PRELIMINARY ASSESSMENT REPORT: Addendum

For the Revised Location of Markham MTS No. 4

CAA ID No. 2002-054

Date: 15th July 2002

DIAGRAM 2

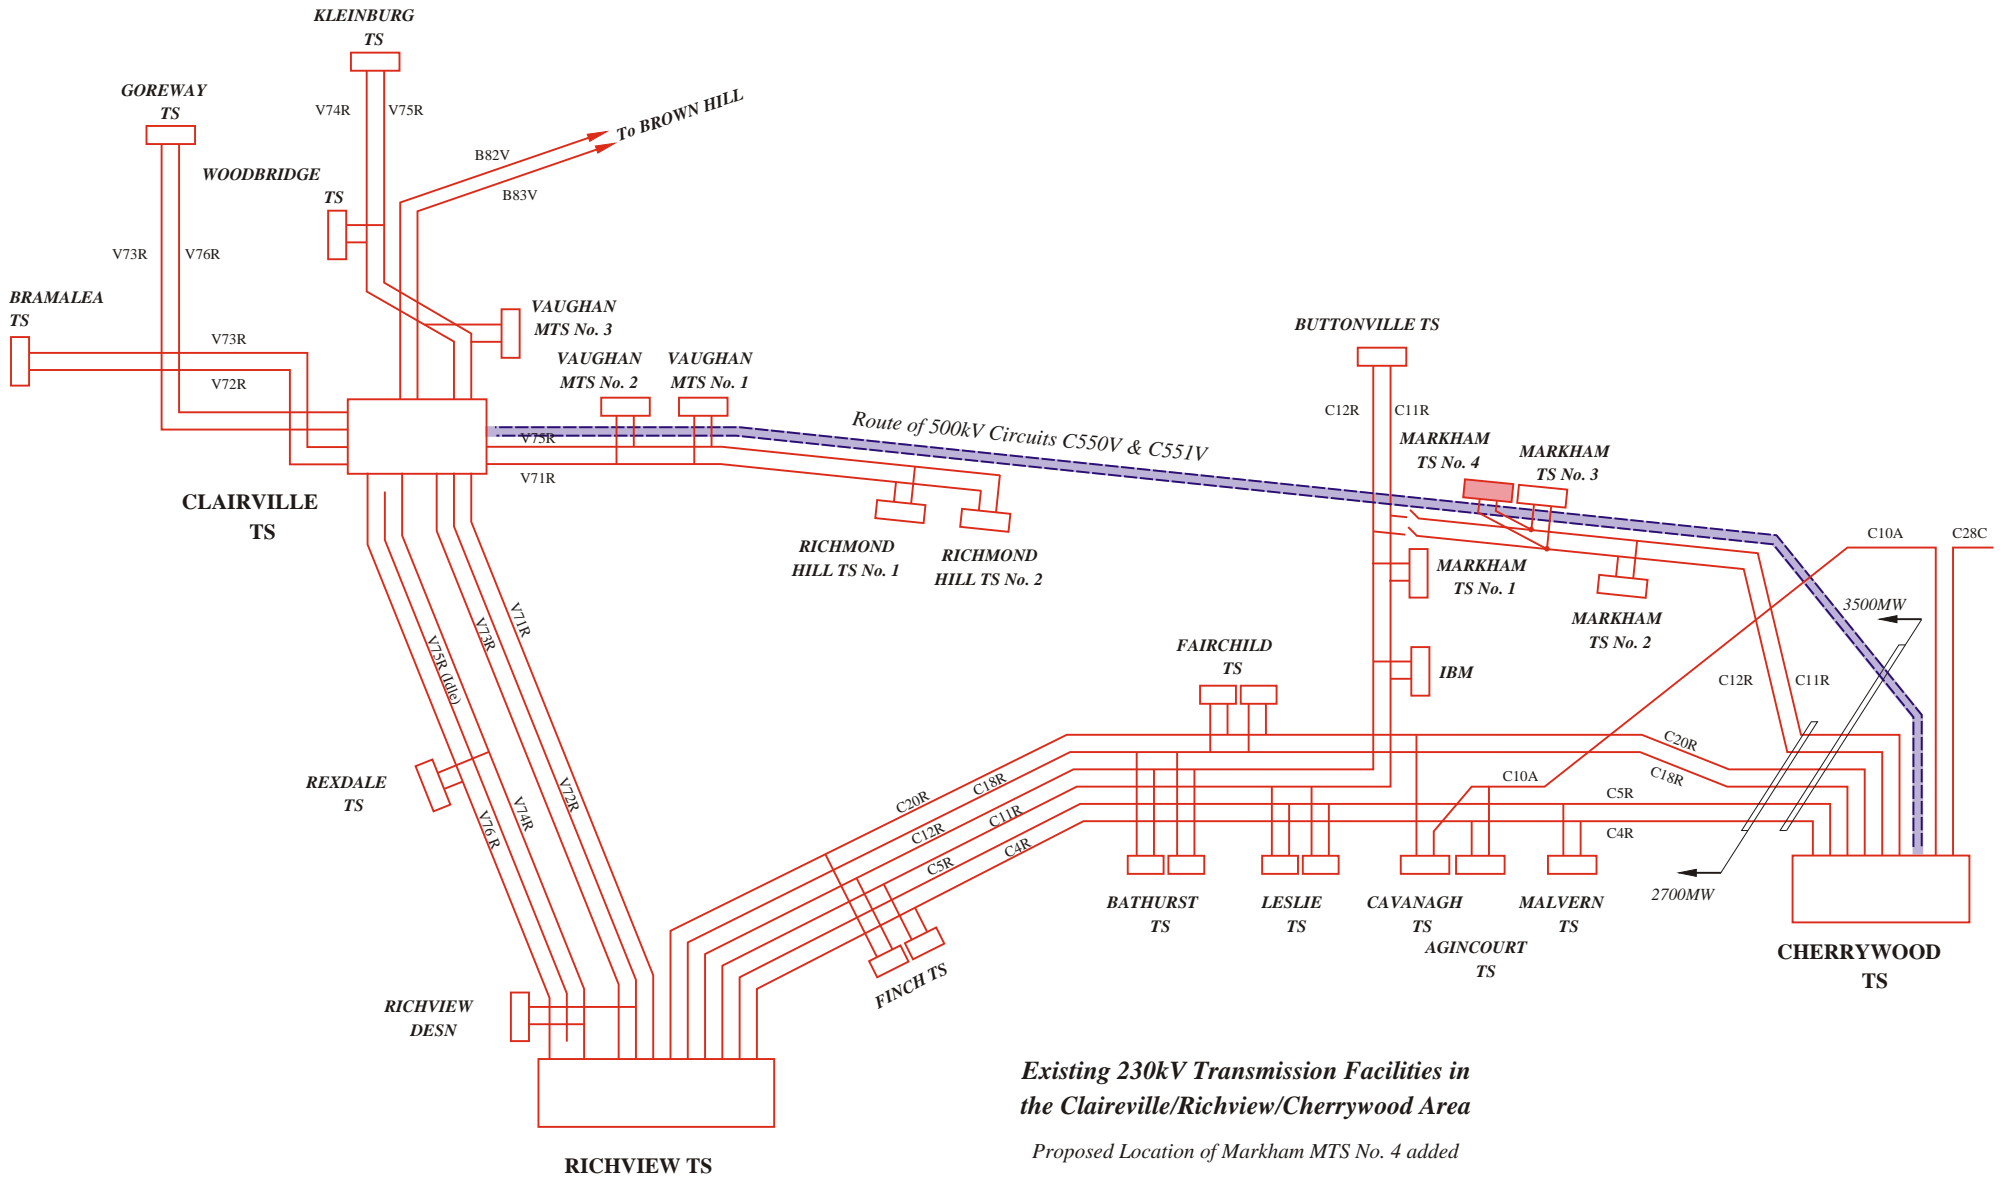
Diagrams 2 to 6 inclusive have been revised to show the proposed connection arrangement of MTS No. 4 in relation to the existing Markham Hydro facilities.

Reference to Diagram 2 shows that of the six circuits between Richview TS and Cherrywood TS, circuits C11R & C12R have the greatest number of connection points that rely solely on these circuits for their supply. These two circuits are also the most heavily loaded.

Since circuit C12R has a continuous summer rating of only 595MVA over the critical section between Cherrywood TS and Markham MTS No. 4, this circuit would be loaded to approximately 86% of its continuous rating, pre-contingency.

DIAGRAM 3
 10th June 2002
 Revised 16th July 2002

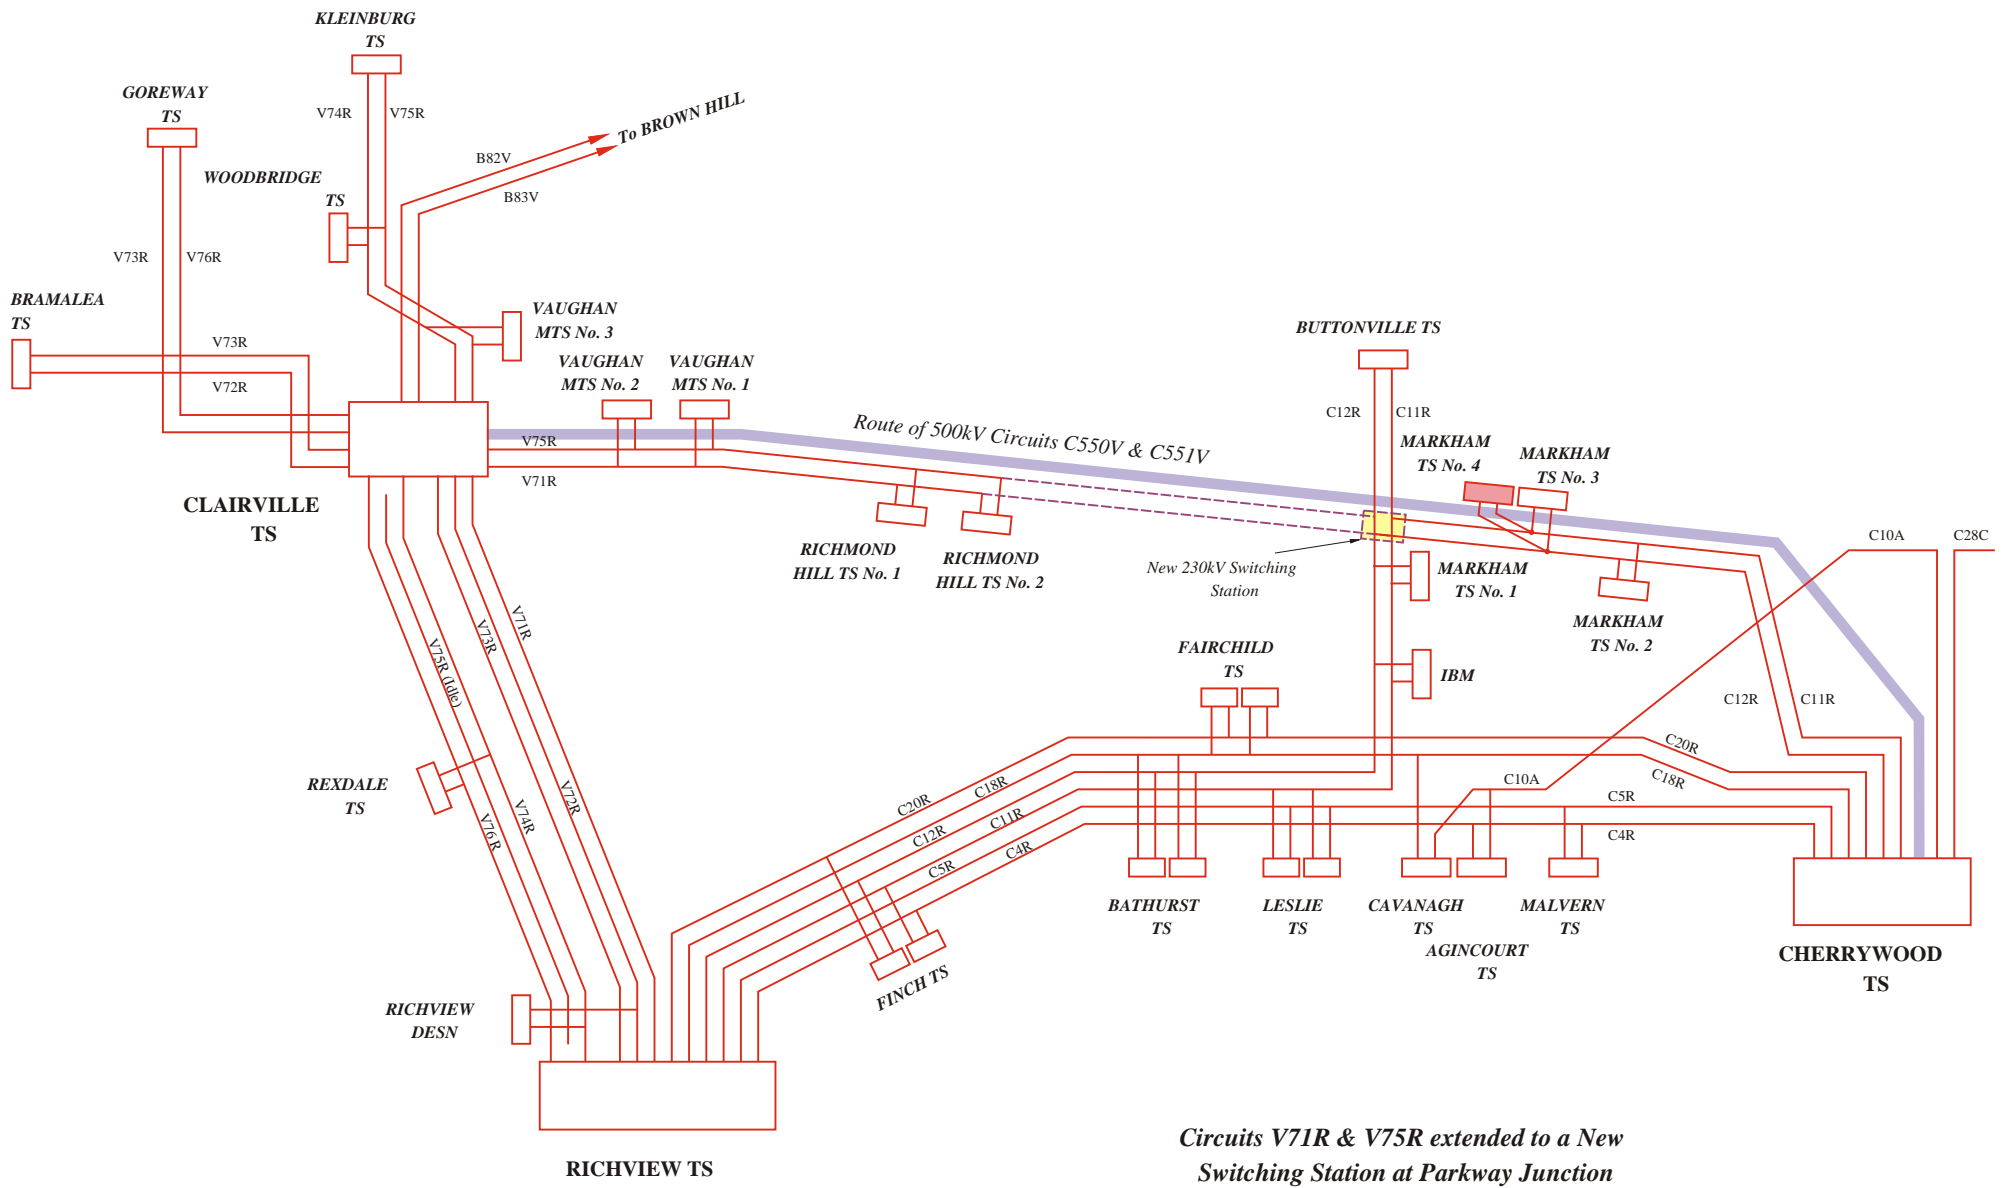
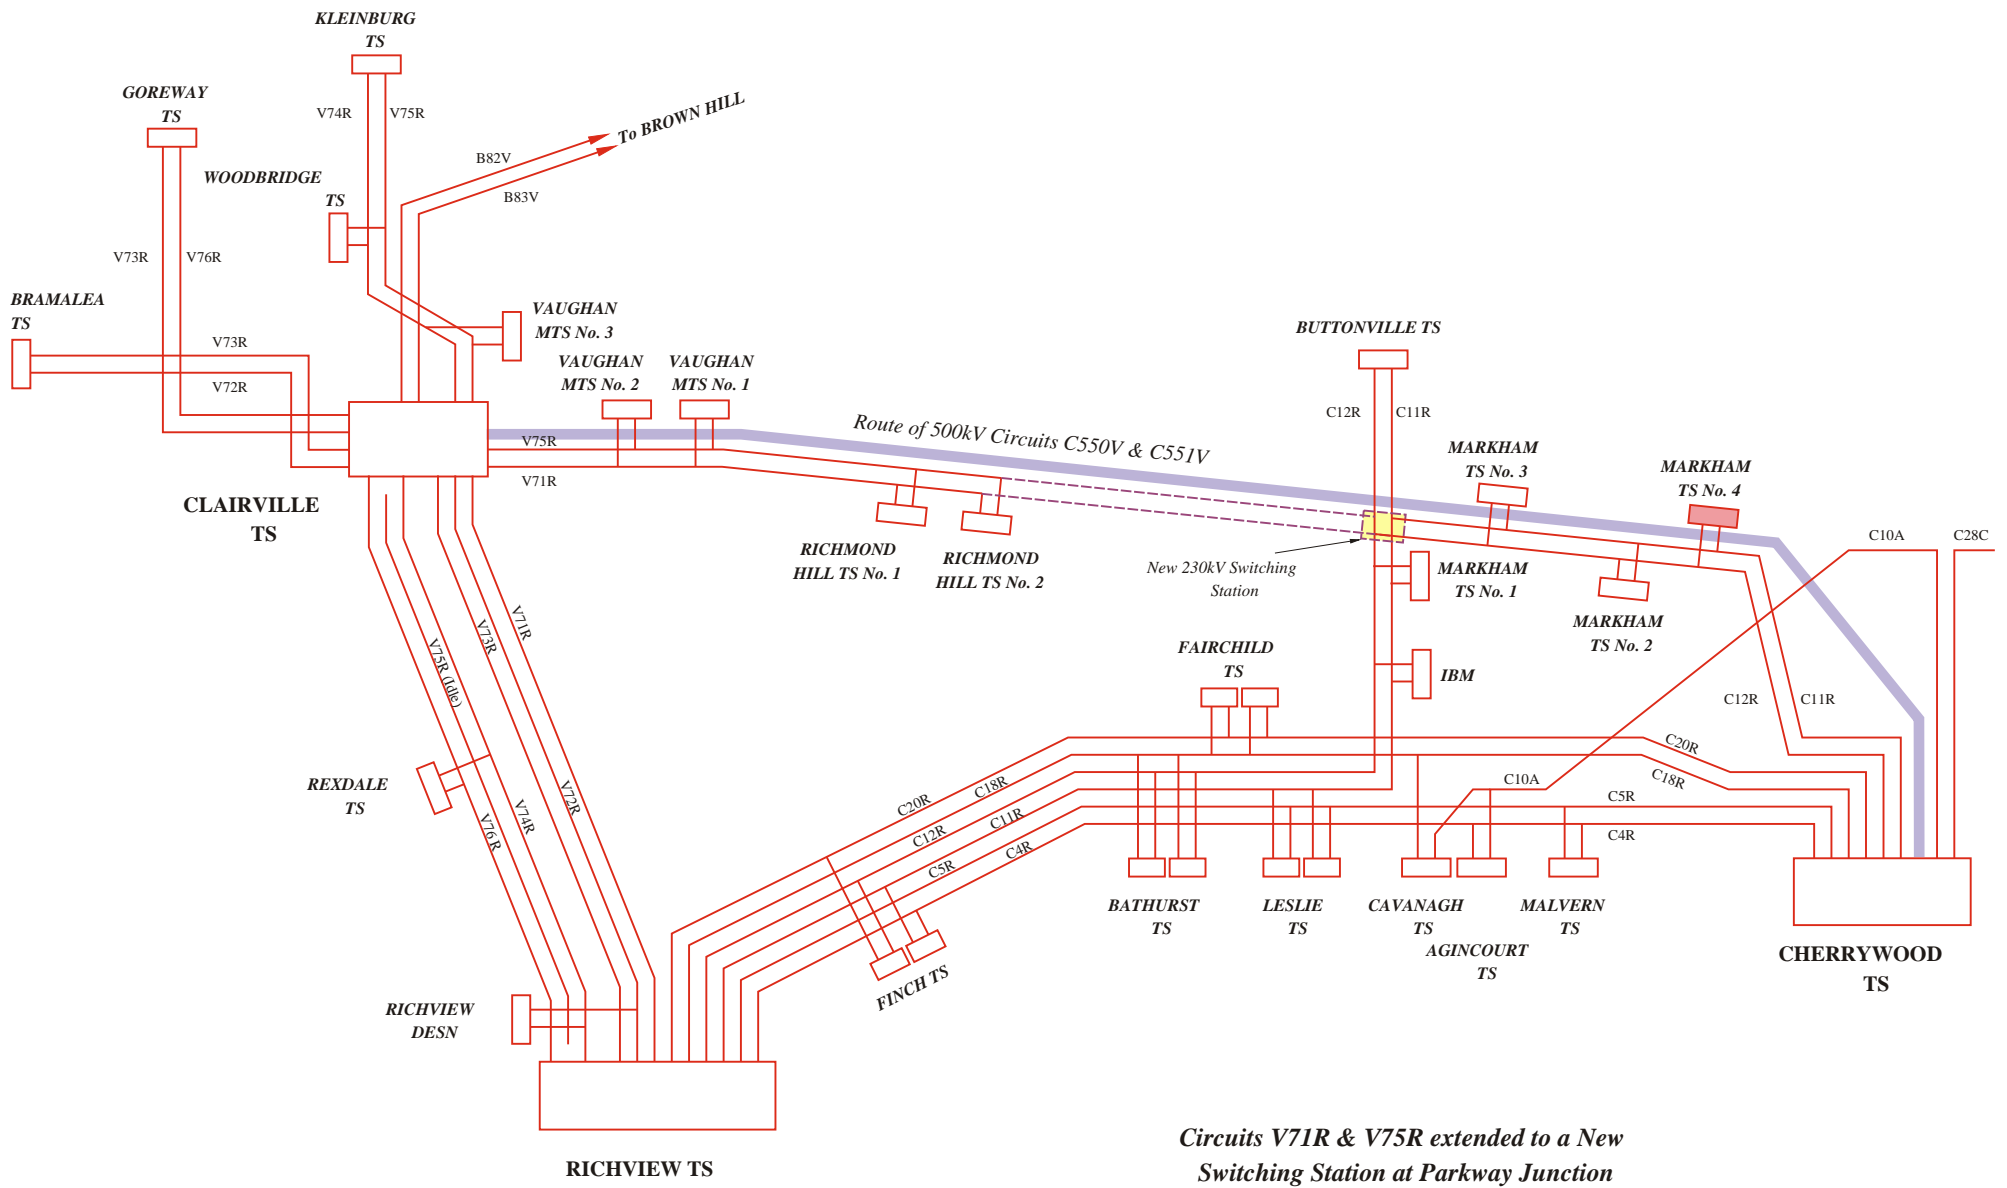
This shows that establishing Parkway Junction switching station and providing a direct connection at 230kV between Cherrywood TS and Claireville TS via circuits V71R & V75R would increase the individual flows on circuits C11R & C12R by approximately 90MVA. This increase would result in the pre-contingency flow on circuit C12R exceeding its continuous rating.

Furthermore, while the post-contingency flow on circuit C12R of approximately 810MVA would remain within its 15-minute limited-time-rating for a contingency involving circuit C11R, there does not appear to be an appropriate control action, other than generation rejection, that could be initiated to reduce the flow to its continuous rating within 15-minutes.

On the assumption that Parkway Junction SS is developed, then the new Markham MTS could be connected to the section of circuits C11R & C12R between Parkway Junction and Cherrywood TS, as shown in Diagram 3. While this would expose three of the Markham MTSs to a possible supply interruption in the event of a double-circuit contingency, this risk could be reduced by introducing normally-open points into this section once additional transmission reinforcement has been provided into the new switching station at Parkway Junction.
